ENCLOSURE 1

MFN 12-112 Sup 2

Markup of GESTAR II US Supplement

Figure S-4. Illustration of Scram and Controlled Entry Region Boundaries, and the BSP Boundary for BSP for DSS-CD [per Reference S-104](#)

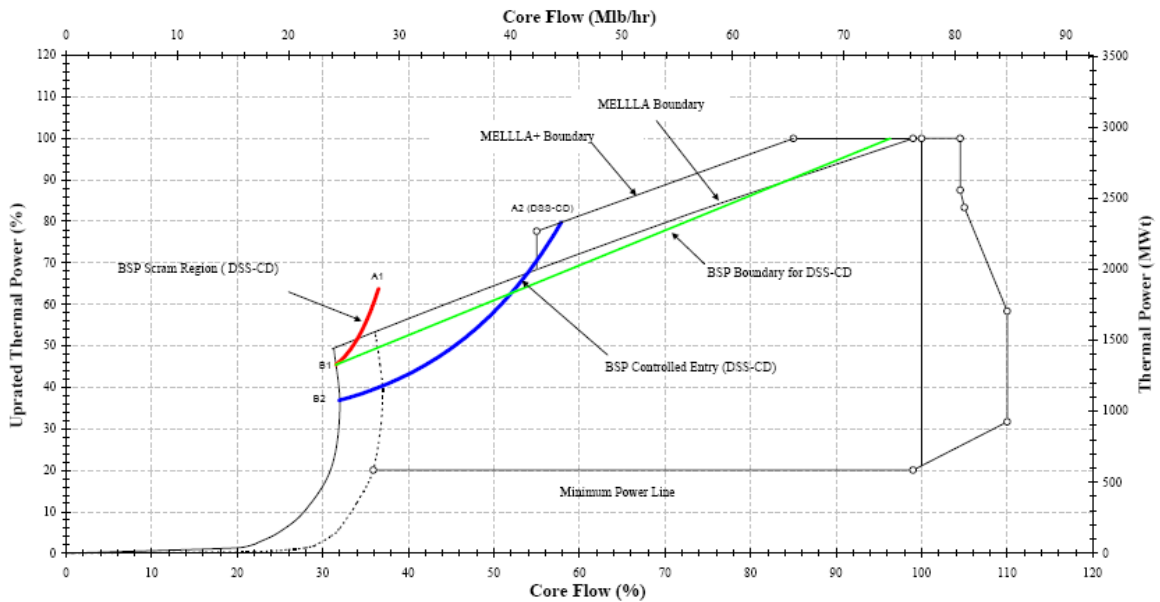
The typical calculated stability region boundaries and the BSP Boundary are illustrated in Figure S-4; the three endpoints A1, B1 and B2 are calculated based on a core DR criterion of 0.80 while the A2 endpoint is calculated based on a core DR criterion of 0.60. The 0.60 criterion for the A2 endpoint (as illustrated in Figure S-4) provides additional stability margins for operation at off-rated conditions and for a two-pump trip to natural circulation flow.

Please note that the actual implemented BSP [region](#) boundaries might be larger due to the Base BSP region definitions. The Base BSP regions for DSS-CD are defined in Reference S-~~103~~104.
